ARCHITECT'S SUPPLEMENTAL INSTRUCTIONS

PROJECT:	The Residence at Green Meadow New Senior Development San Angelo, TX	Report No.	Six (6)
OWNER:	Overland Property Group Dan Maximuk 234 N. Santa Fe Ave, Suite A Salina, KS 67401	Date	May 20, 2025
CONTRACTOR:	MCP Group 3501 SW Fairlawn Rd. Topeka, KS 66614	Architect's Proj No.	24-3395
		Contract For:	General Construction Mechanical, Electrical

1. Eliminate the ground-mounted monument sign along Green Meadow Drive. Reference attached revised Sheets A1.1, A1.2, ME1.1, E6.1 and E6.3
2. Add new wall-mounted sign on south-east exterior wall, facing Green Meadow Drive. Add new wall mounted sign lighting. Reference attached revised sheets A3.1, E1.2, E6.1 and E6.3.

A1.2

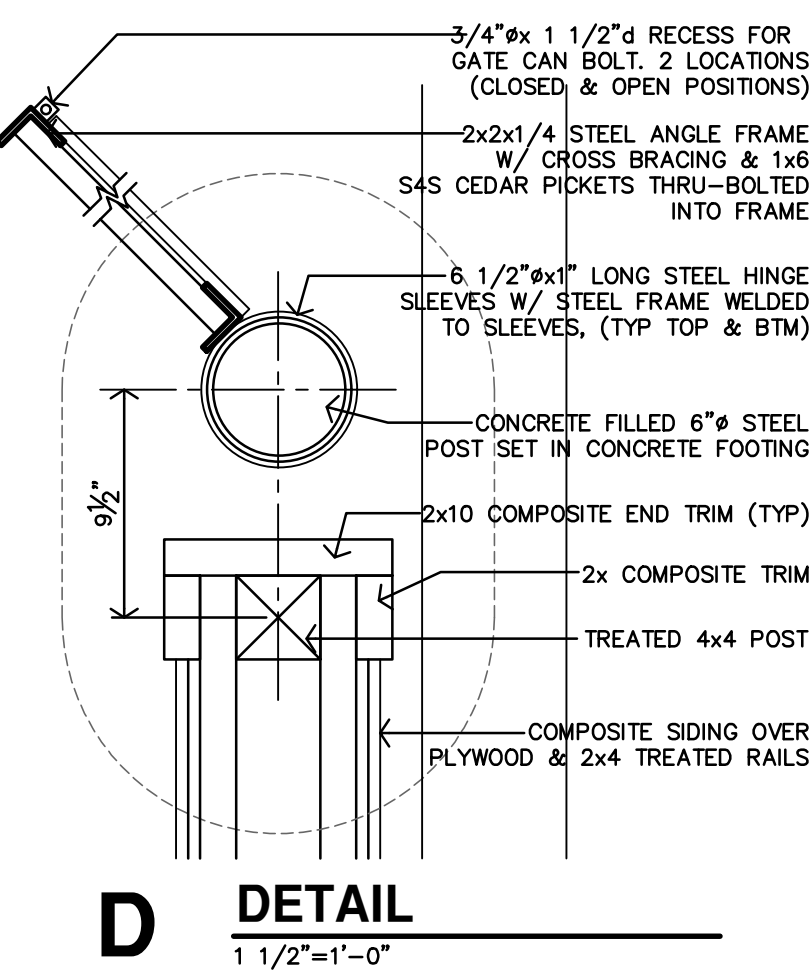
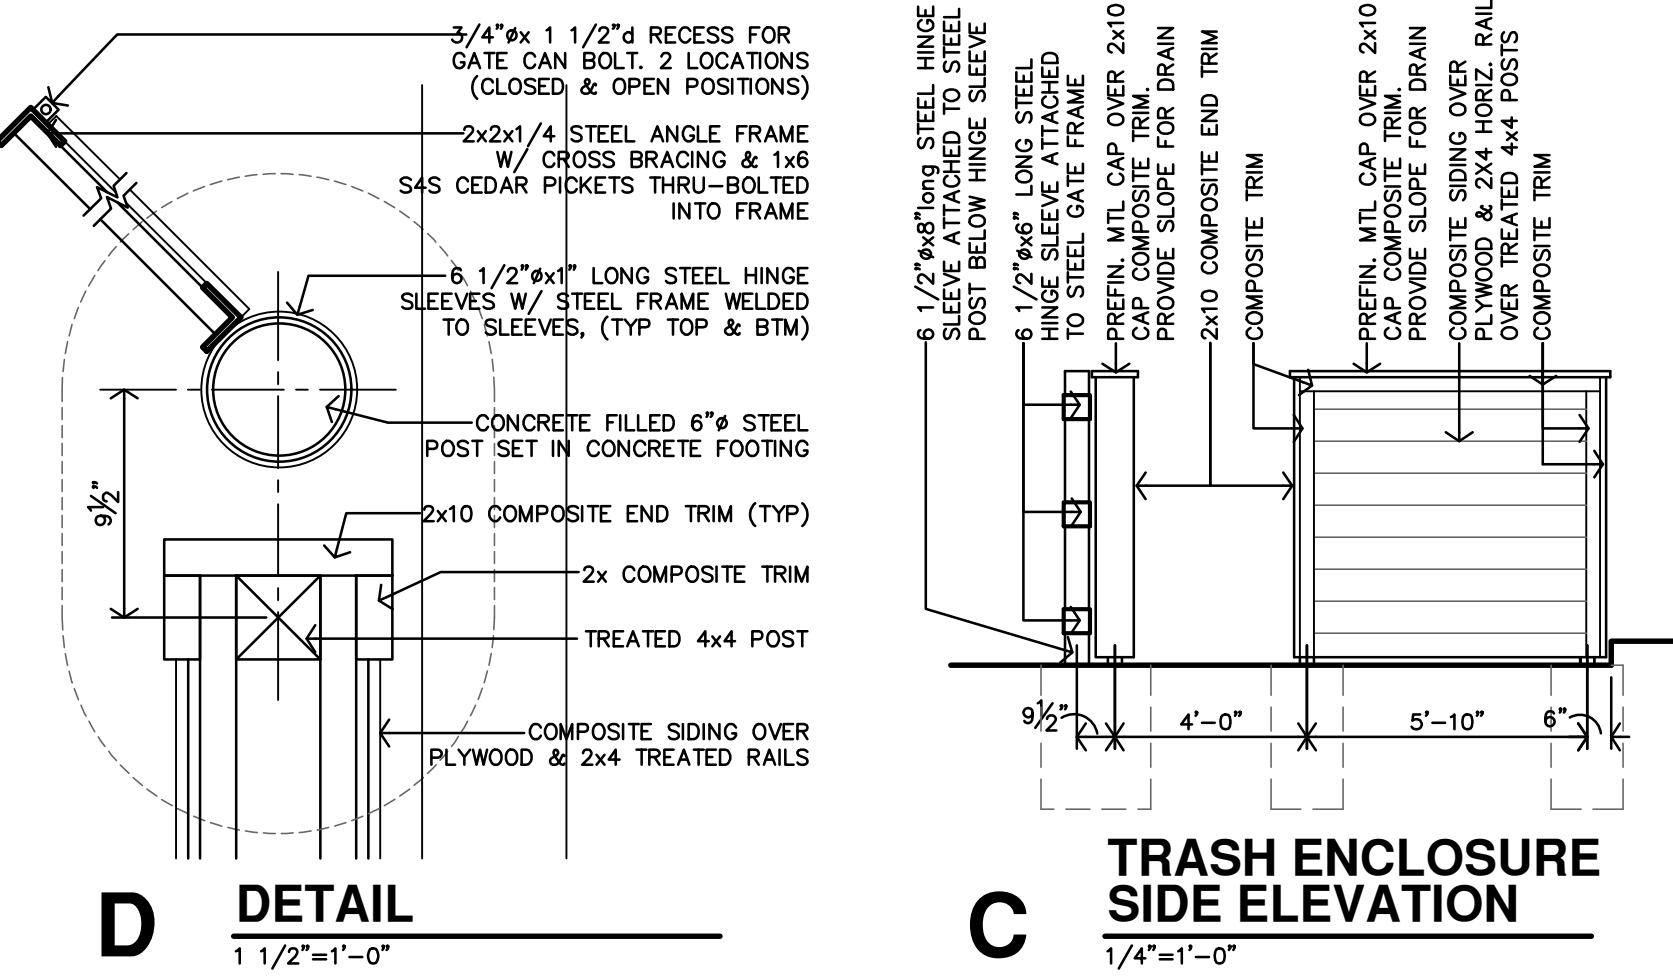
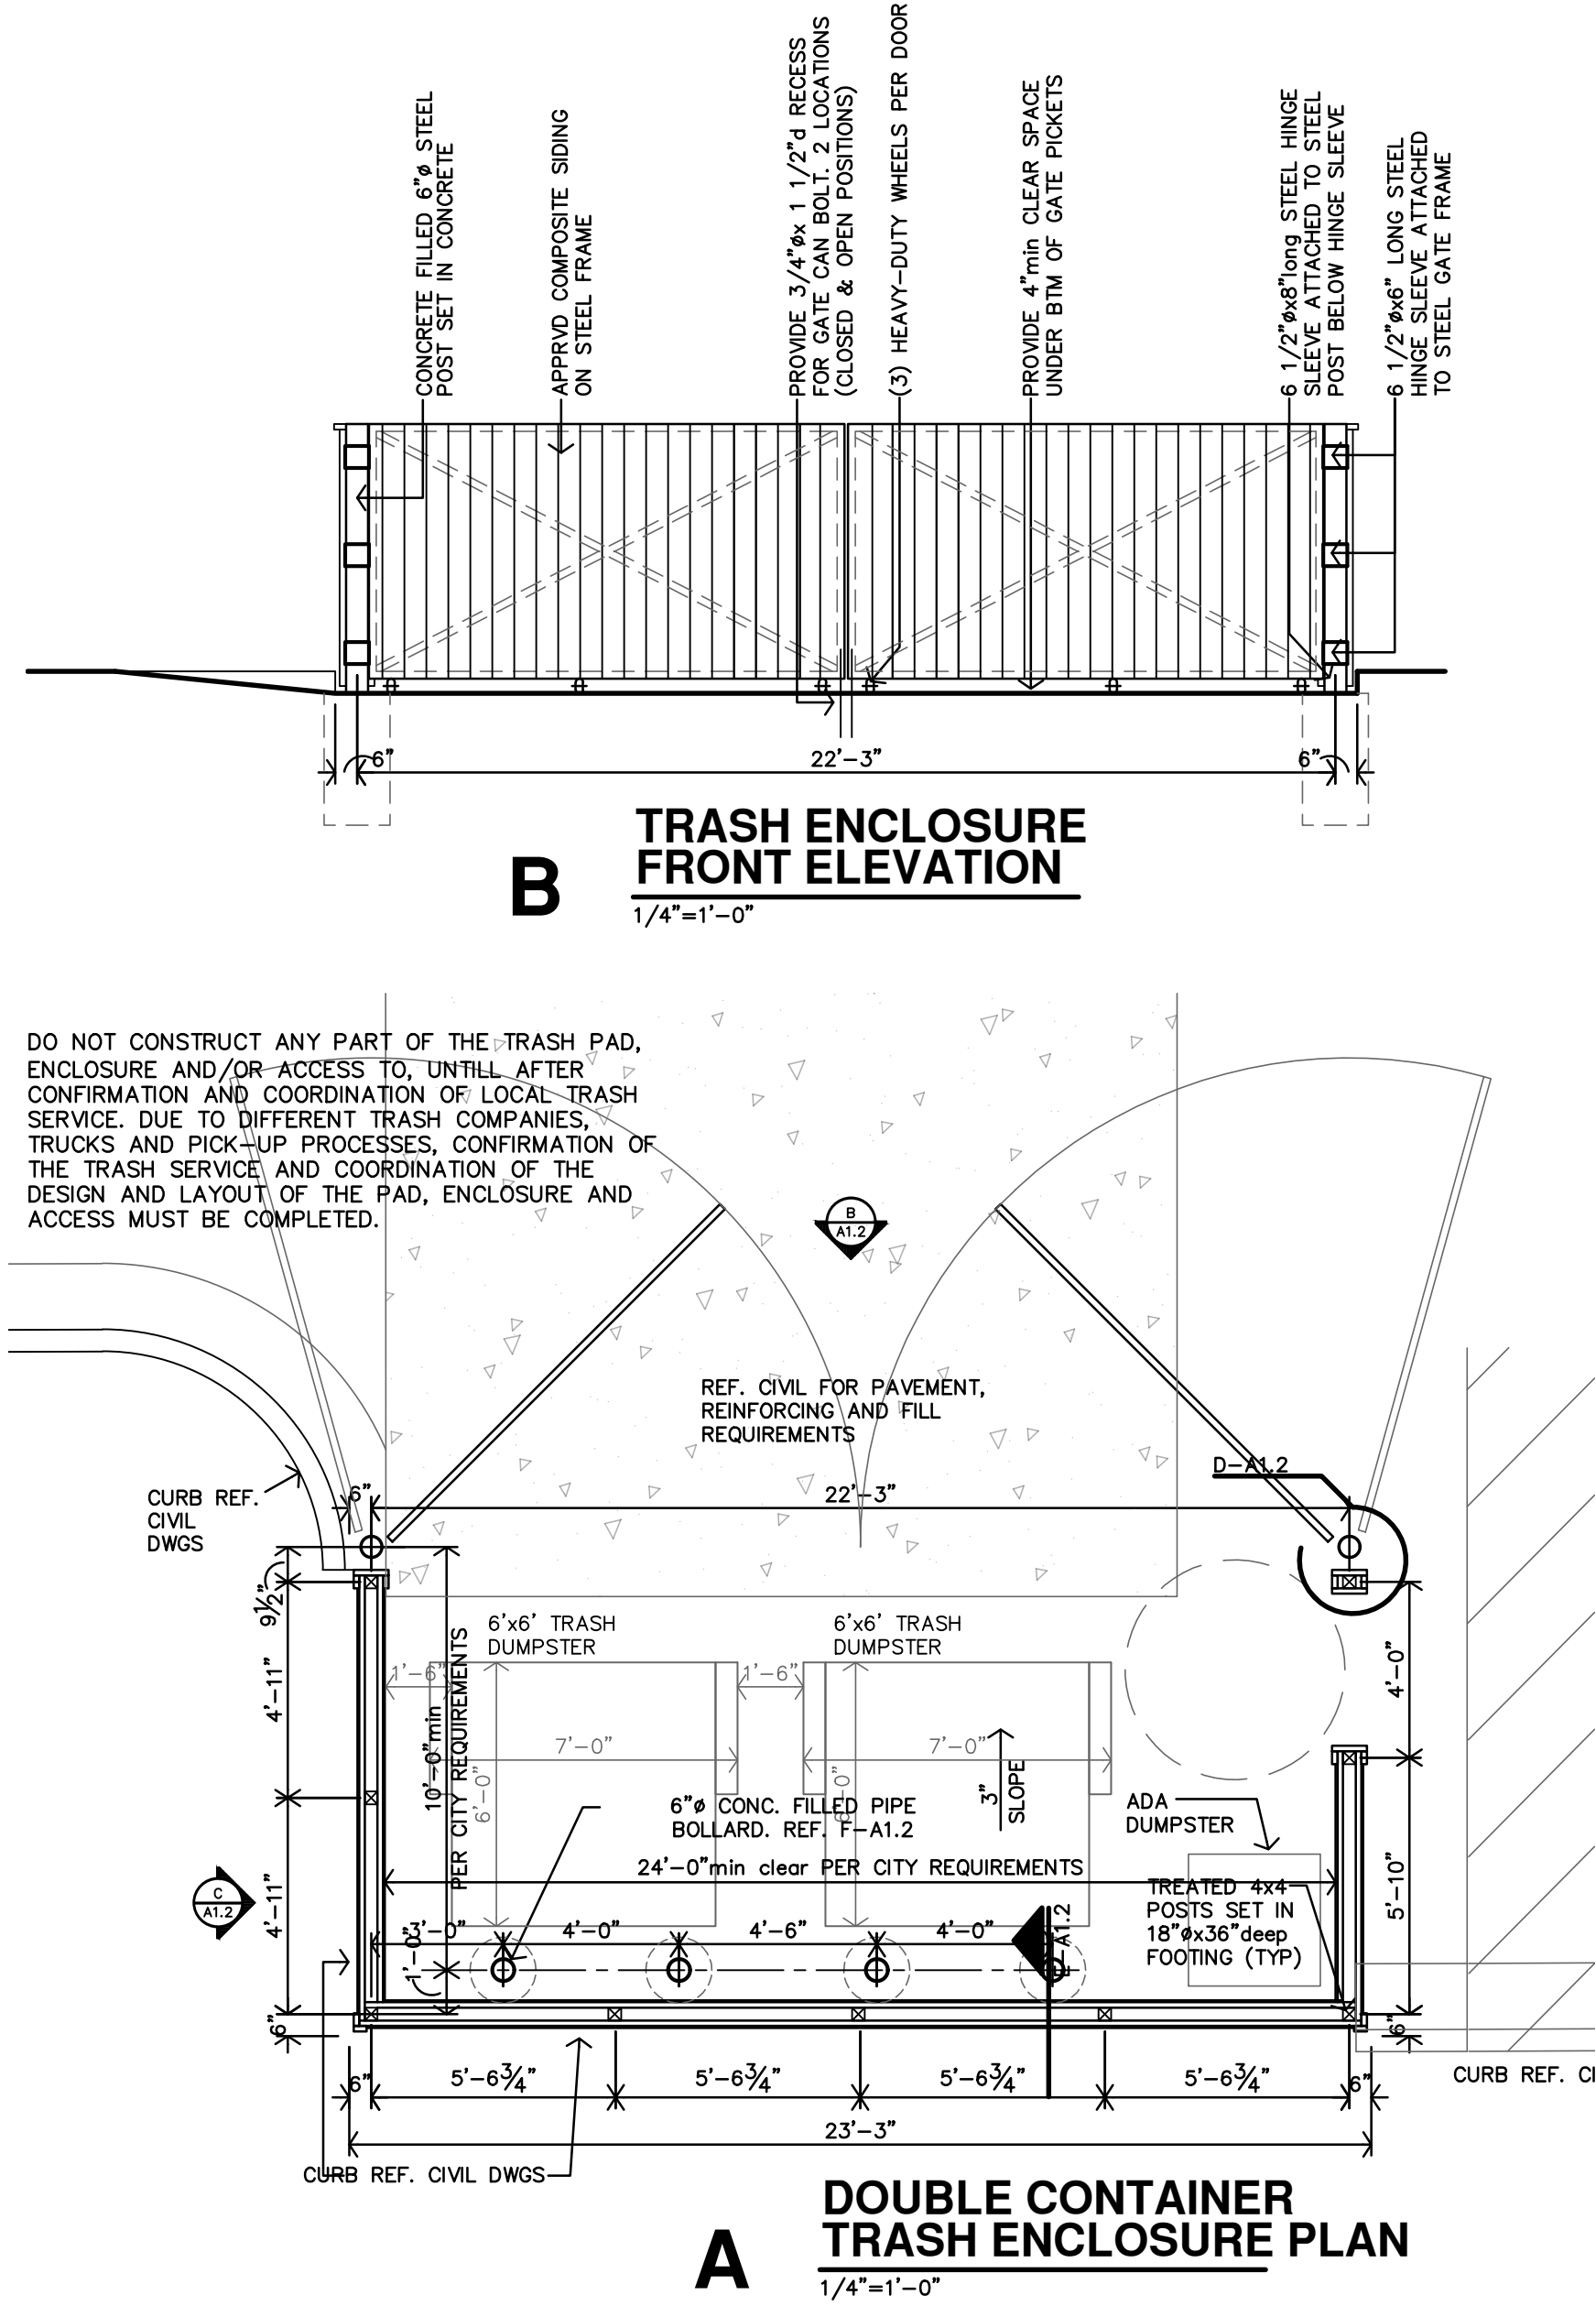
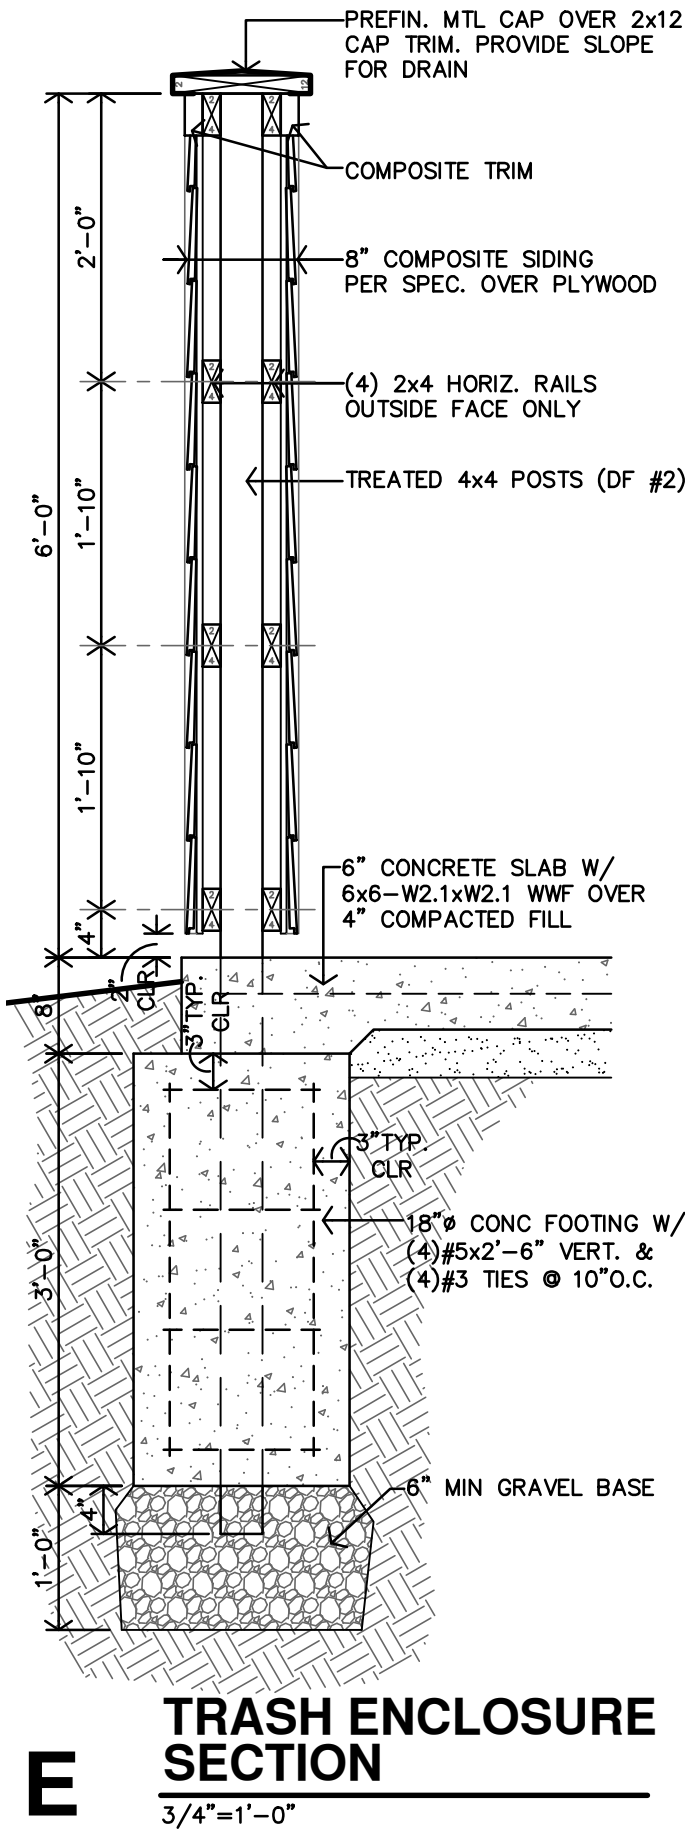
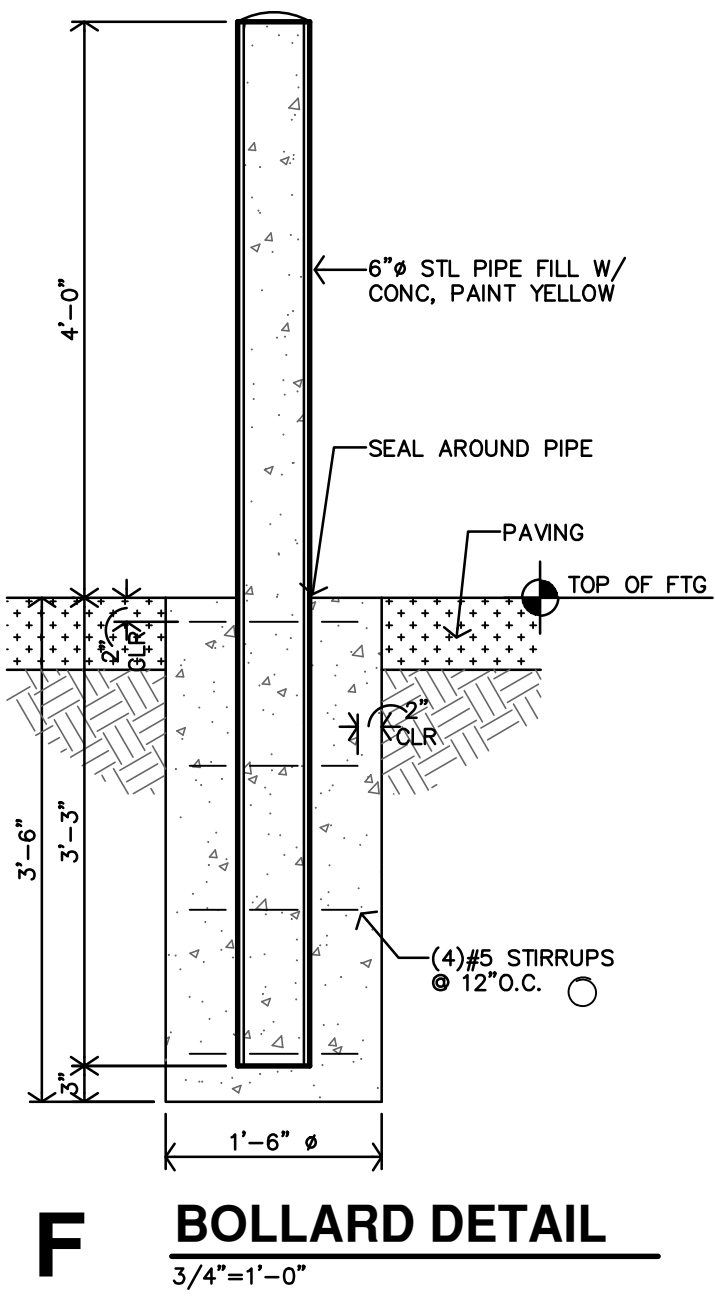
DETAILS G, H, J & K ELIMINATED
